Fox Run Addition (Phase II)
Pond Plan
Wichita, Kansas

| 117 E. Lewis, Wichita, KS 67202 (316)284-0242 | PROJECT NUMBER | | | SHEET 3.0 |

Typical Slope Protection
Detention Pond

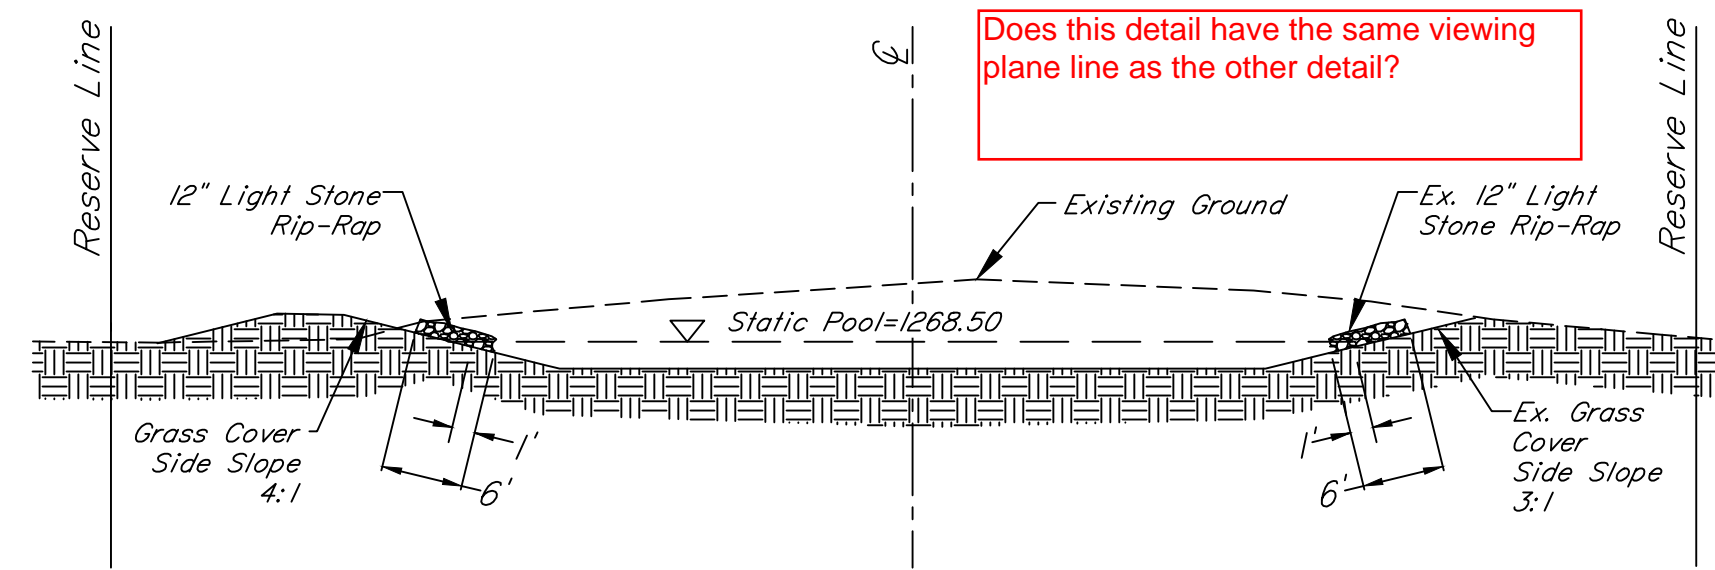
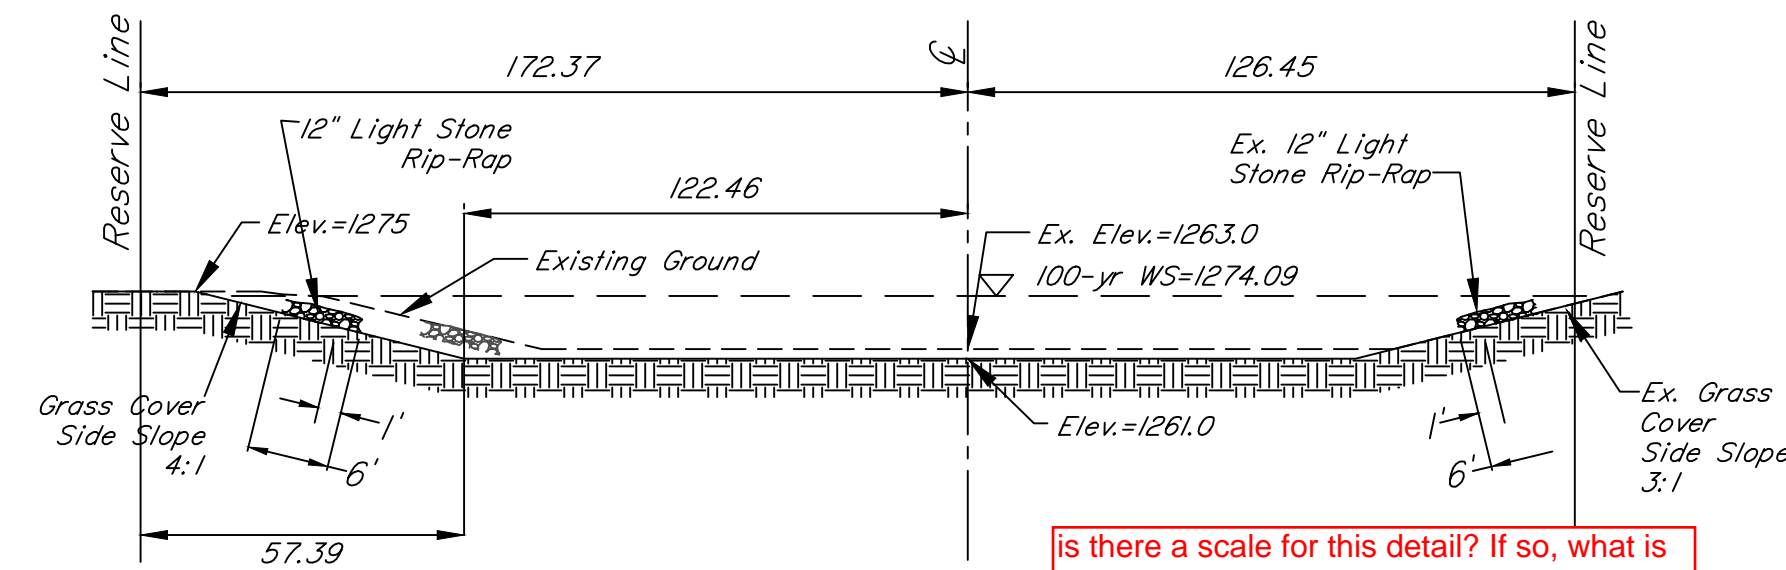
Does this detail have the same viewing plane line as the other detail?

Section PI-PI
Detention Pond

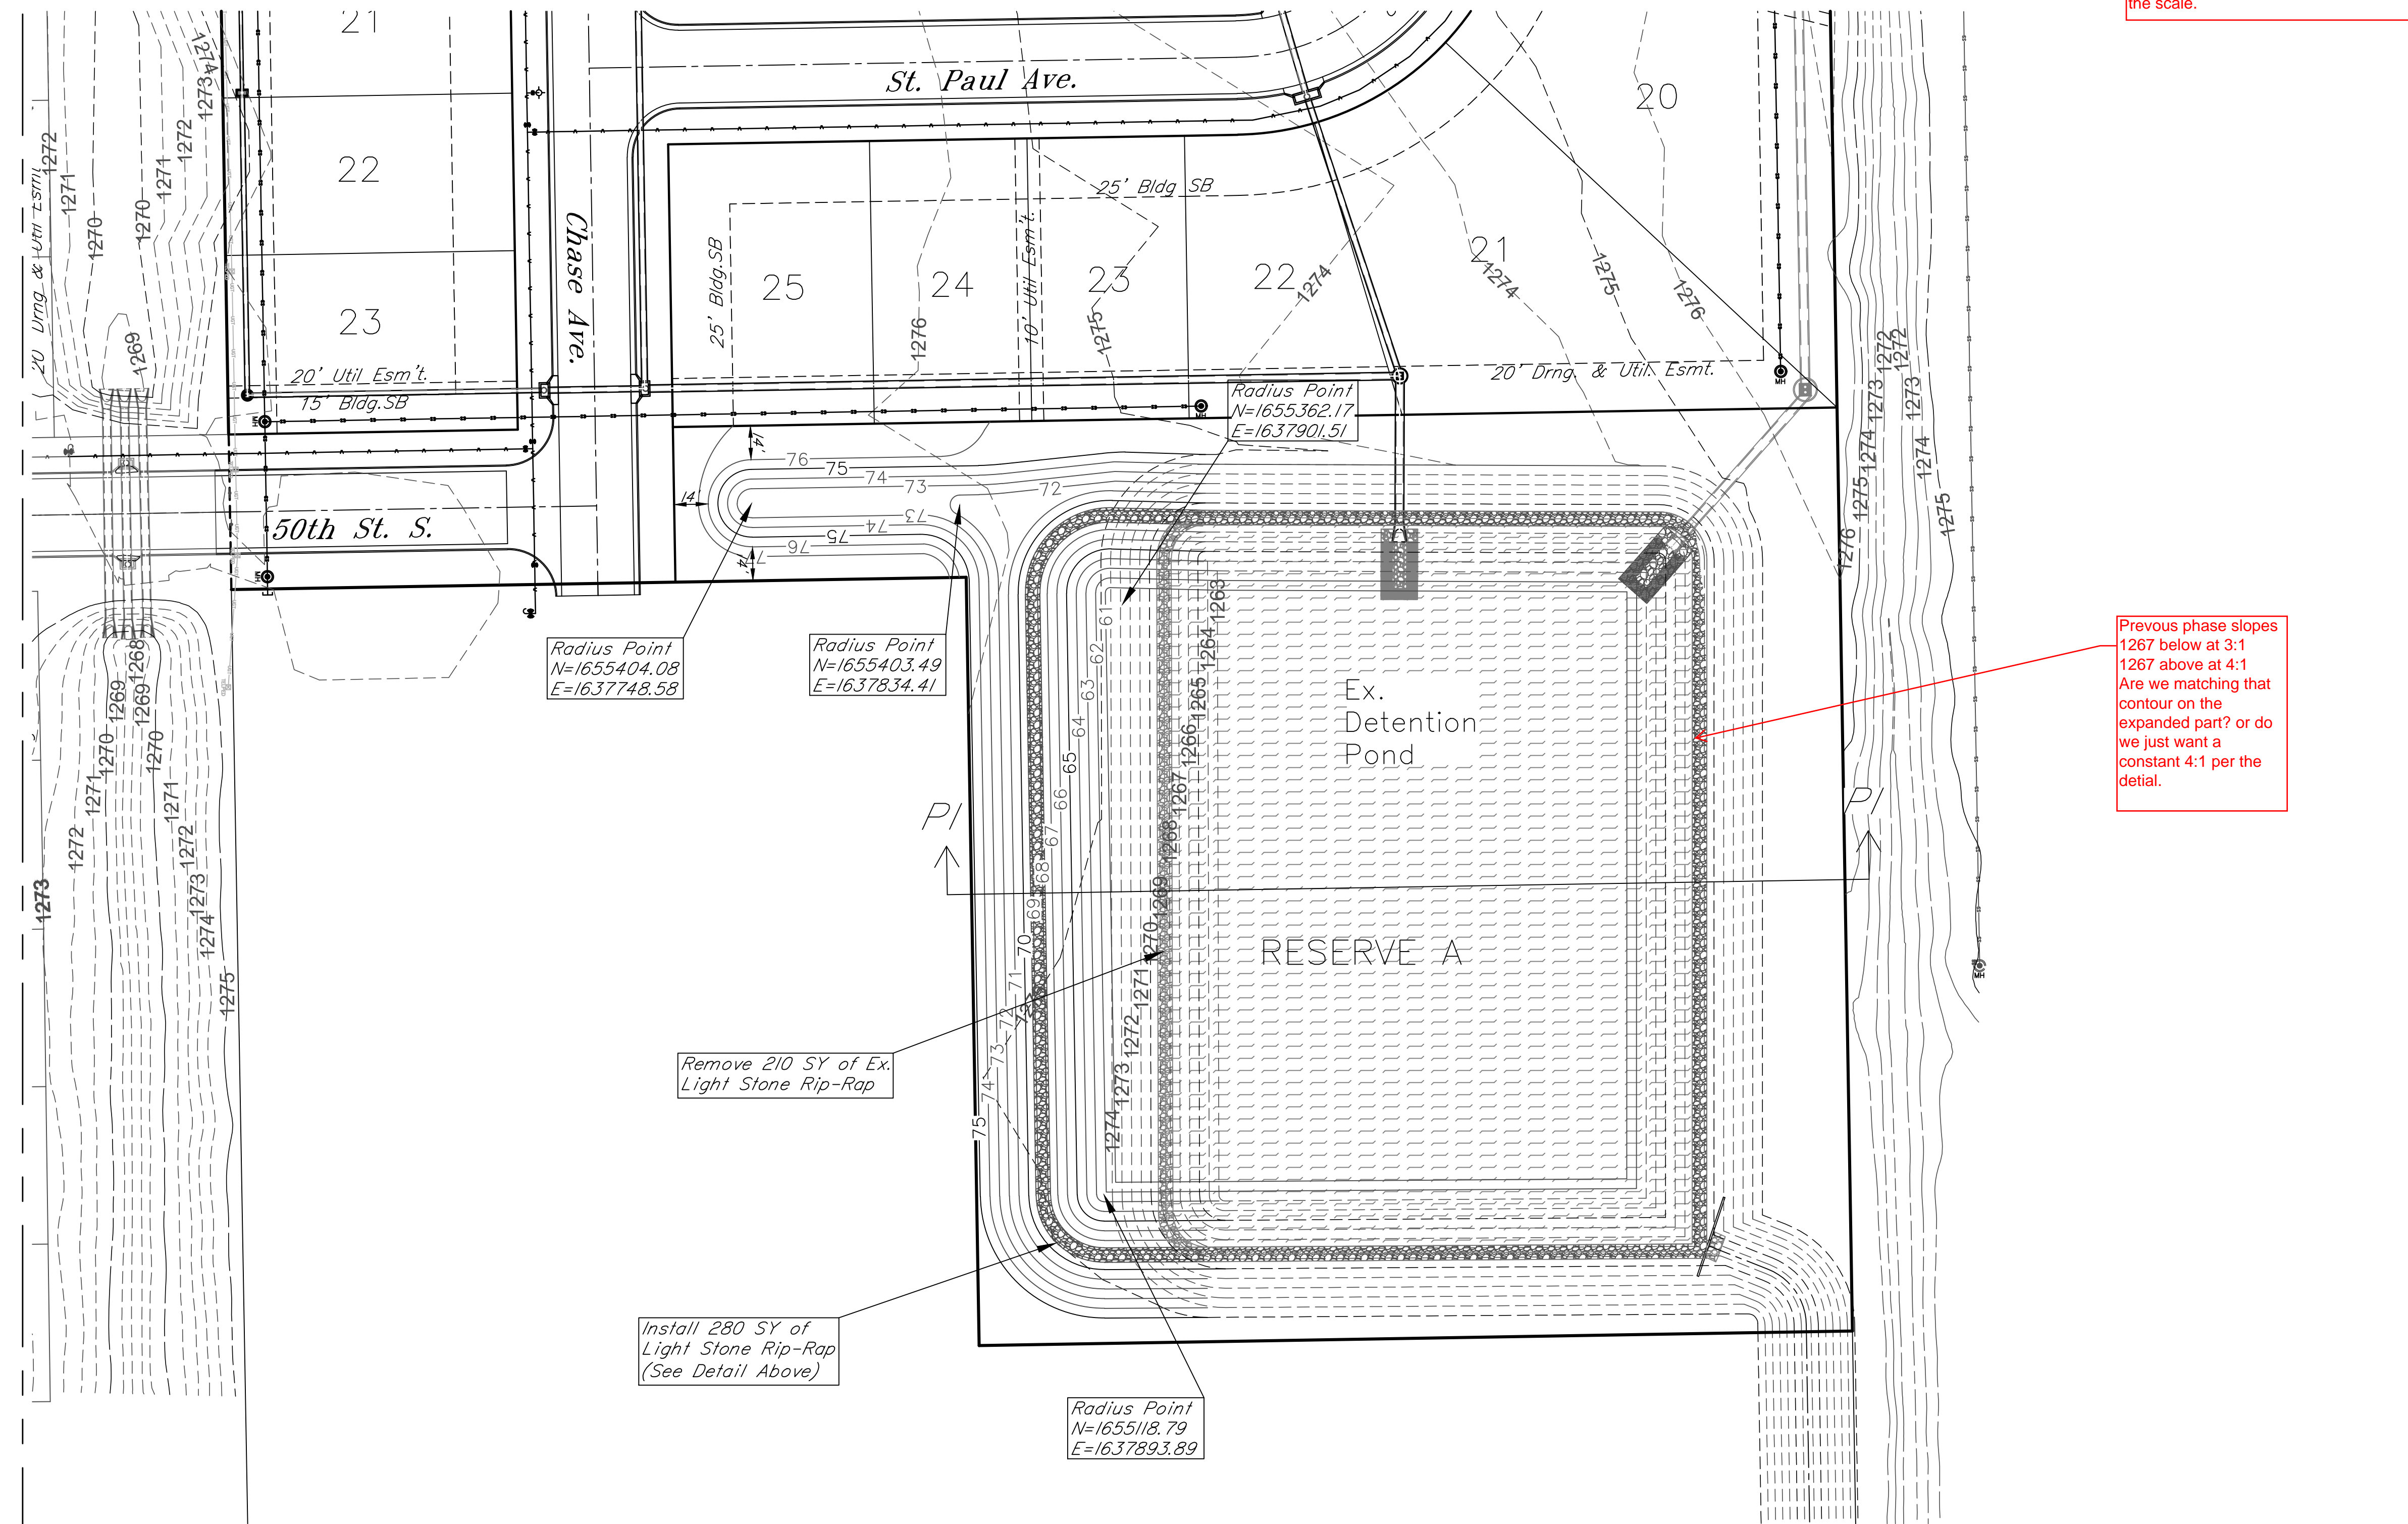
is there a scale for this detail? If so, what is the scale.

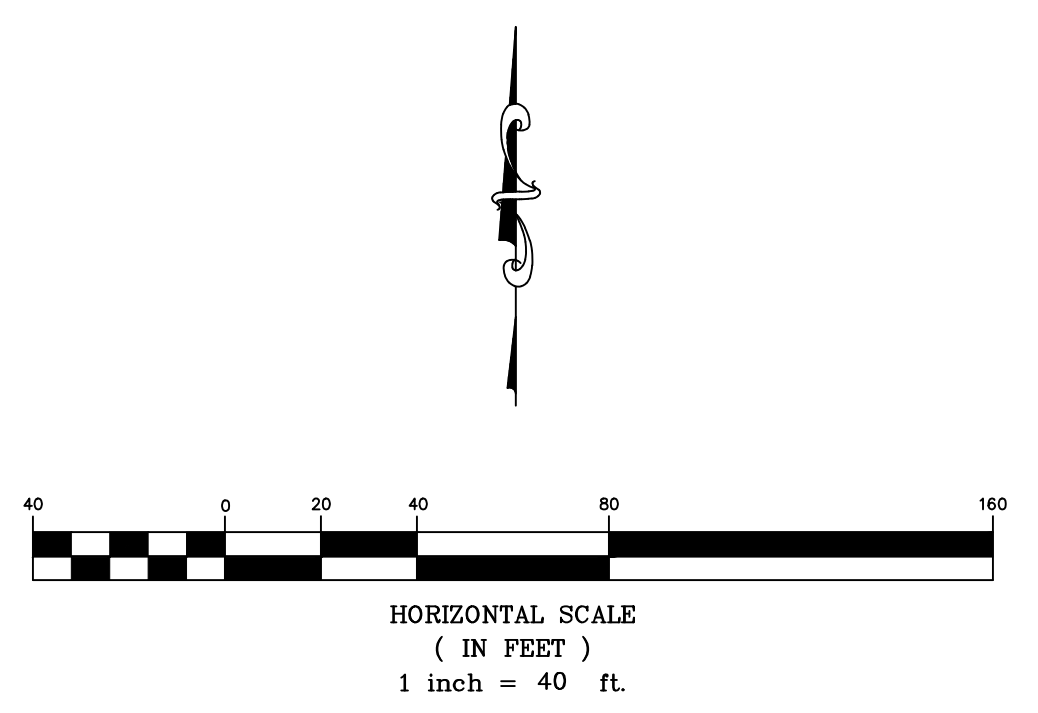
Previous phase slopes
1267 below at 3:1
1267 above at 4:1
Are we matching that
contour on the
expanded part? or do
we just want a
constant 4:1 per the
detail.
